## MEMORANDUM

**TO:** PLANNING COMMISSION  
**FROM:** KEN ONDICH – PLANNING / COMMUNITY DEVELOPMENT DIRECTOR  
**SUBJECT:** REQUEST FOR CONDITIONAL USE PERMIT #C5-2024 TO ALLOW FOR AN EXPANSION OF A HEALTH CARE FACILITY AT 301 2<sup>ND</sup> STREET NE AS PROPOSED BY MAYO CLINIC HEALTH SYSTEM.  
**DATE:** 10/16/24

Site and Grading Plan

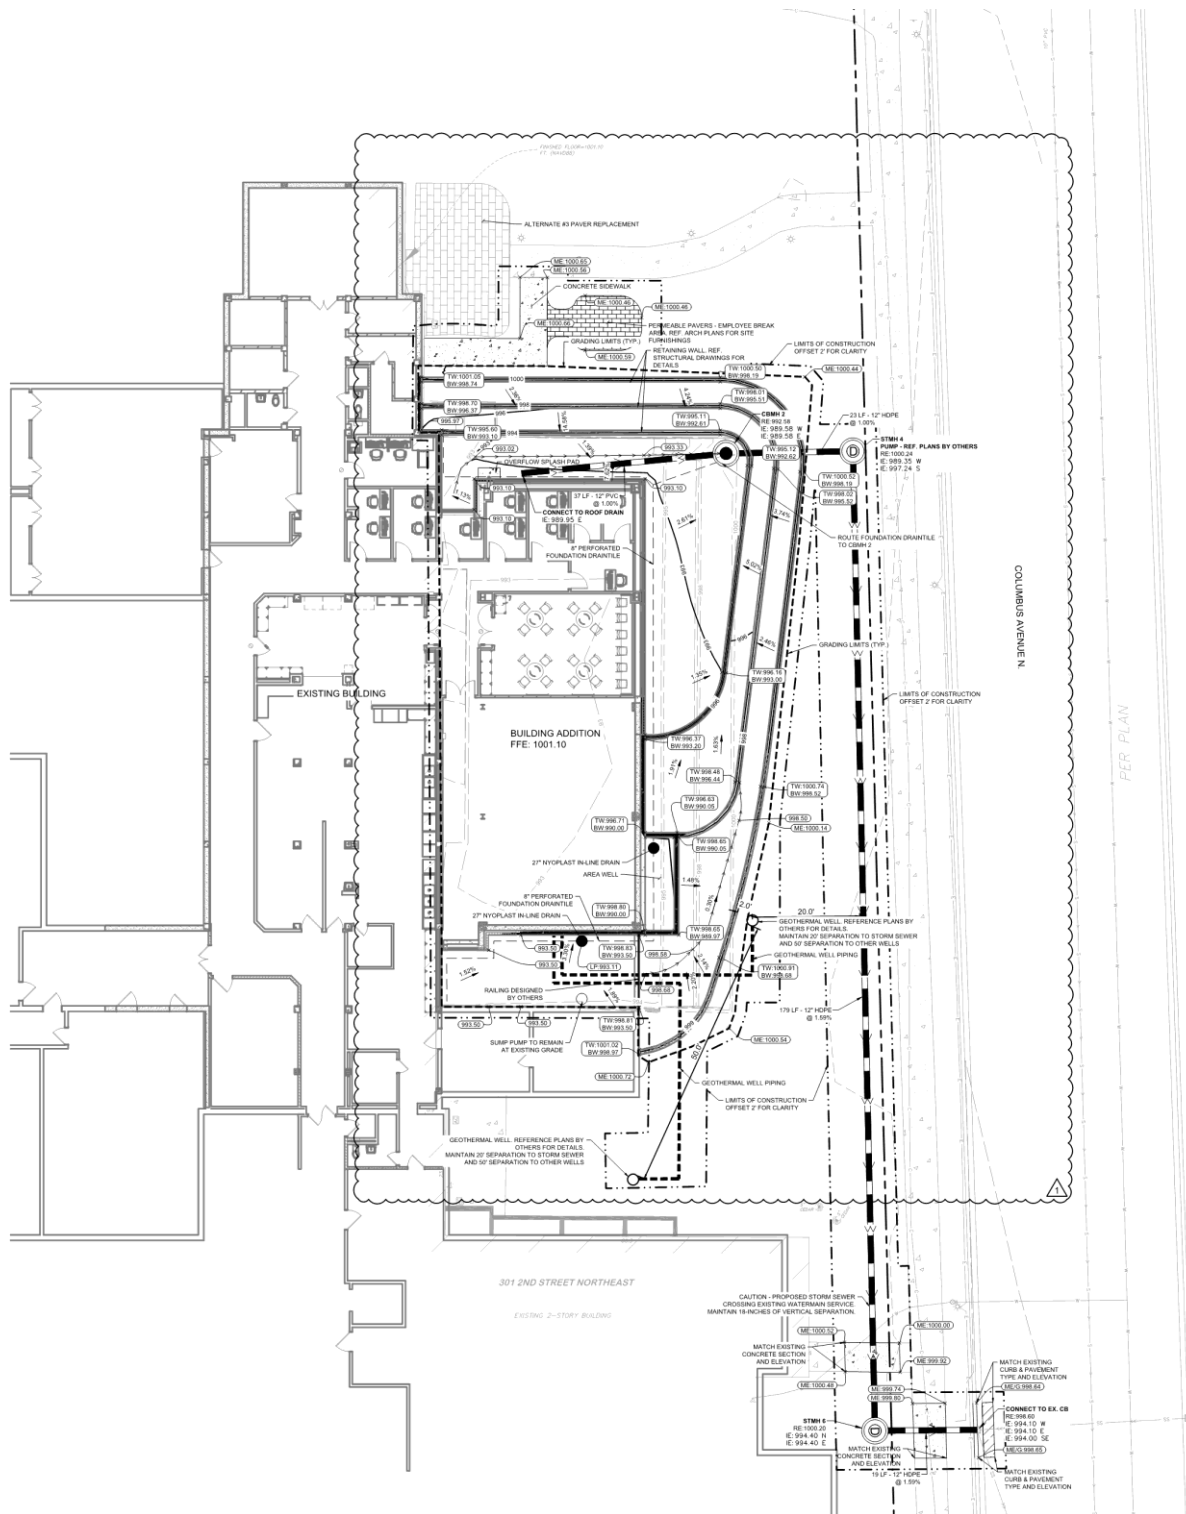
6. On north side of building, a HP is noted as EL. 993.02 and drains toward an intake CBMH2 with a rim elevation 993.36. This appears to be an error or the site will hold water there.
